**CALIFORNIA REGIONAL WATER QUALITY CONTROL BOARD
SAN DIEGO REGION**

STAFF REPORT

**Proposed Administrative Civil Liability
Contained in Complaint No. R9-2009-0040
City of Laguna Beach
Sewage Collection System**

August 18, 2009

Figure 1: Dry Well – typical layout of the discharge side of each pump

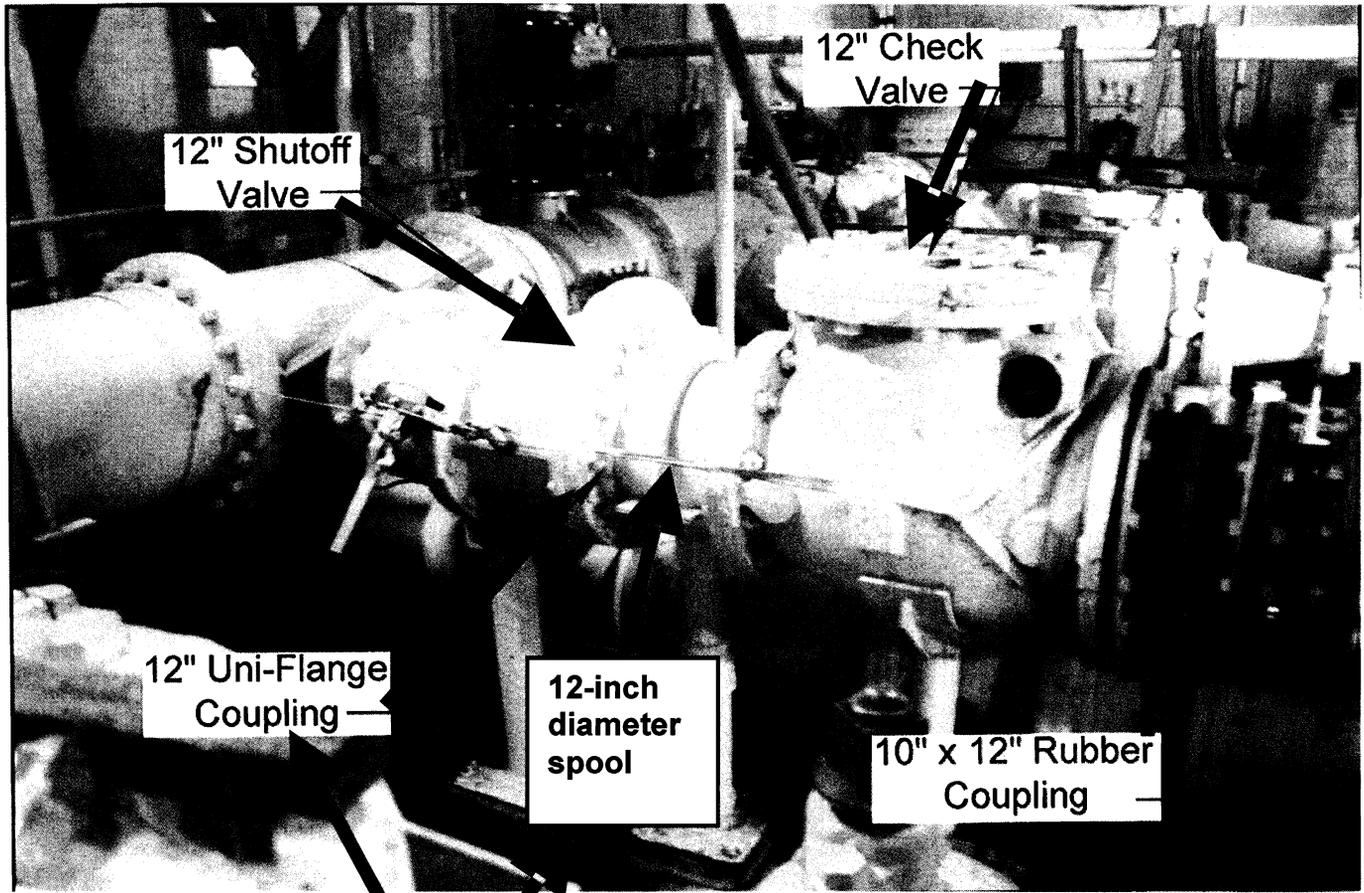
One of the upgrades to the lift station included in the rehabilitation project was replacement of two of the four pumps in the dry well (Pump Nos. 1 and 2). On October 22, 2008, Pump Nos. 1 and 2 were isolated from the force main by closing the shutoff gate valve (12-inch resilient wedge gate valve) on the discharge side. The shutoff gate valve was closed by turning the valve until it stopped. There were no other checks to ensure the shutoff gate valve was closed. The Discharger ensured that the pump was isolated from the check valve by draining the pressure from the pump. After isolation, the two pumps were removed. On October 28, 2008, one of the new pumps (Pump No. 2) was installed and tested at various rates. The other new pump (Pump No. 1) was in place, but not connected to the discharge side (i.e. there was still a gap between the new Pump No. 1 and the check valve on the discharge side of Pump No. 1) (see Figure 1 – Note 1).

NOTE 2: On October 29, 2008, the SSO flowed out of a crack between the coupling and spool.

As a result, the sewage seeped through the shutoff gate valve and pushed on the check valve. This caused lateral movement of the check valve and spool, away from the improperly installed Uni-Flange and the shutoff gate valve. The sewage spilled out of the crack between the spool and the Uni-Flange. (See Figure 1 above)
